Subject: RE: DM/24/2933 - 23 Meadow Drive Lindfield Haywards Heath West Sussex RH16 2RS

Thank you for consulting the Flood Risk and Drainage Team with regard to the above application. We understand the application is for demolition of existing garage and erection of a two storey rear and side extension and new front porch. The Flood Risk Assessment provided by the Applicant has been reviewed, and we would comment as follows:

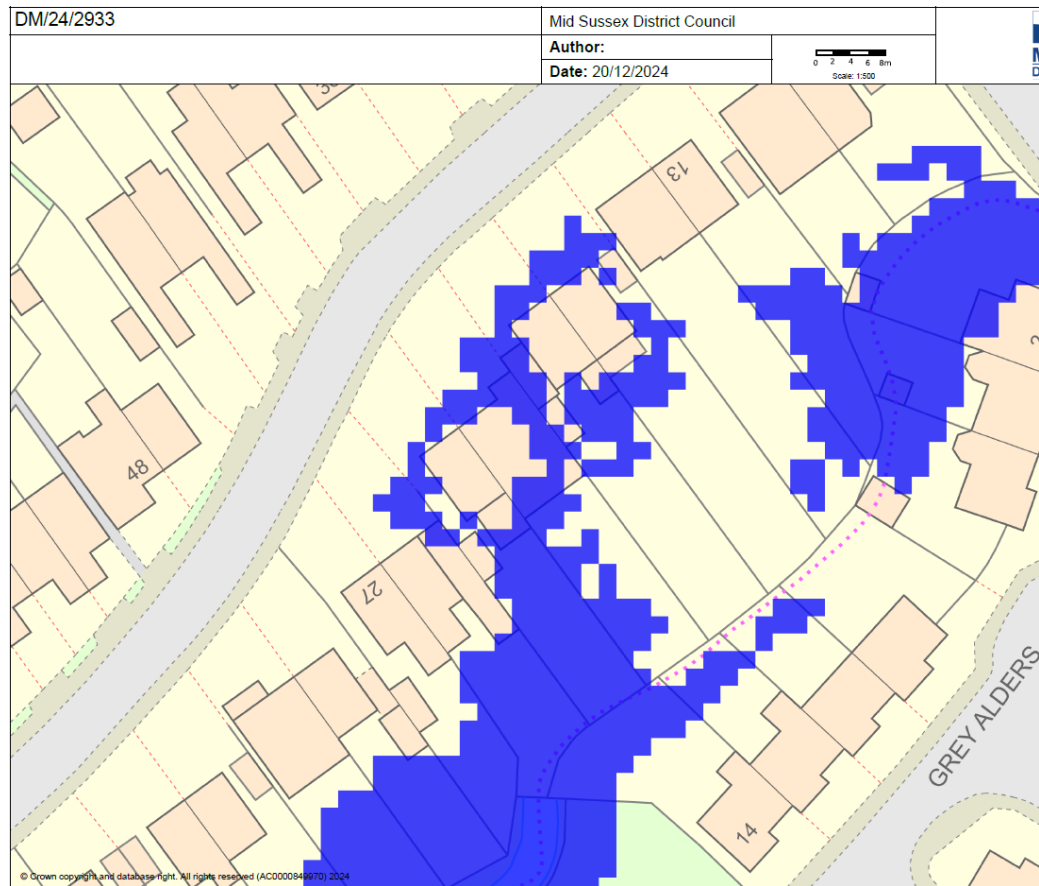
- In order to assist please see above extract from our Environment Agency mapping of the surface water flood extents. There is a publicly available searchable and downloadable maps available: Defra Data Services Platform (select the relevant layers for the 1:30, 1:100 and/or 1:1000 extents) Please could the Applicant overlay their proposed extension footprint on the above (or similar) screenshot of the 1:30 flood extent for us to review any encroachment?

If the proposal is outside of this extent then additional resistance and resilience mitigation will need to be evidenced at this location, as this development is classified as 'more vulnerable'.

In addition, the Flood and Drainage Team would have no objection to the scheme if surface water modelling can be provided which demonstrates that the development design ensures that, for the 1:100 year + climate change event:

- Site users are safe in the event of a flood
- There is no loss of floodplain storage
- There is no impedance of overland flows
- There is no increase in flood risk

Please find attached a drawing with the flood map added which shows that there is minimal encroachment.

With this minimal encroachment please can it be confirmed that the surface water modelling is not required.

We are happy to include measures to ensure the property is protected. The proposal maintains a route for surface water to - if required - flow around the building with the route made clearer by the removal of the garage.

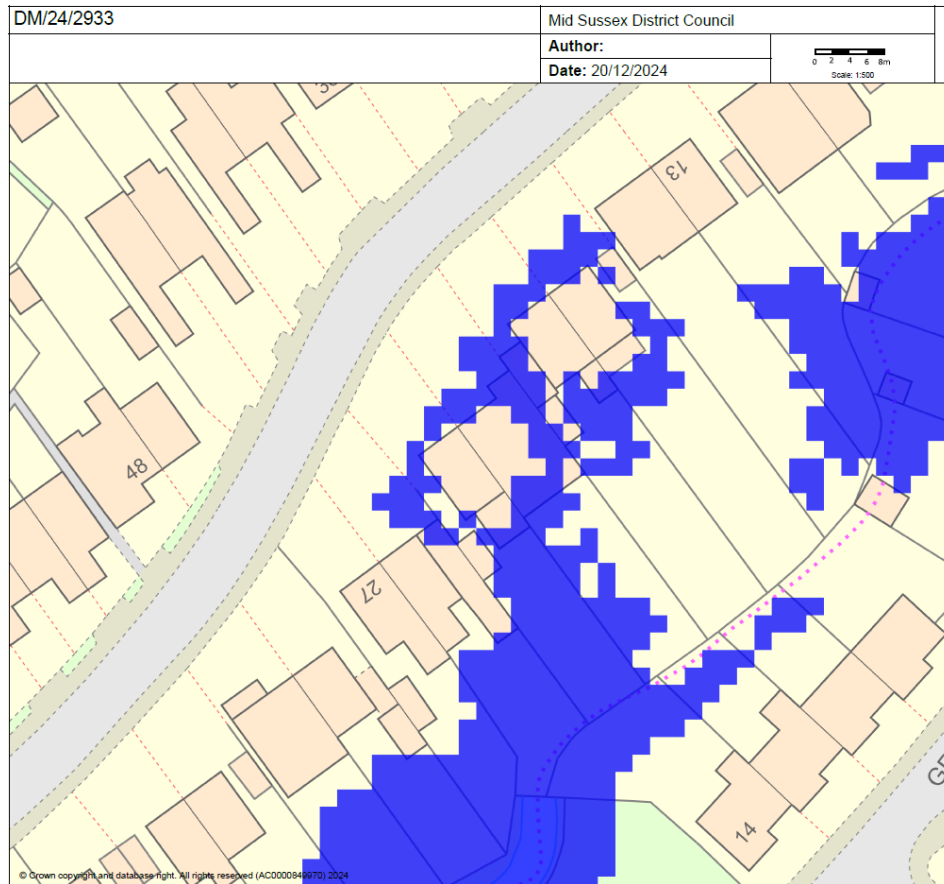
The site is in flood zone 1 and is at low fluvial flood risk (risk of flooding from Main Rivers). The site is shown to be at very low, low, medium, and high surface water flood risk (comparable to flood zone 3b, 3a, 2 and 1).

The proposed development site is located within an area impacted by the 1:30, 1:100 and 1:1,000 flood events (high, medium, and low surface water flood risk). Following the approach set out under the NPPF for assessing fluvial flood risk (flood zones) this area would be considered consistent with Flood Zone 3b (1:30 extent), Flood Zone 3a (1:100 extent), and Flood Zone 2 (1:1000 extent).

Based on the latest guidance that all sources of flooding should be considered consistently the site meets one of the reasons an area would be considered functional floodplain (Flood Zone 3b); it's location within the 1:30 surface water flood extent.

It is the Flood Risk and Drainage Team's findings that, following the latest guidance on assessing flood risk the site is located within the equivalent of Flood Zone 3b (1:30 flood extent) and the proposed development is a more vulnerable development.

In addition, the Flood and Drainage Team would have no objection to the scheme if surface water modelling can be provided which demonstrates that the development design ensures that, for the 1:100 year + climate change event:
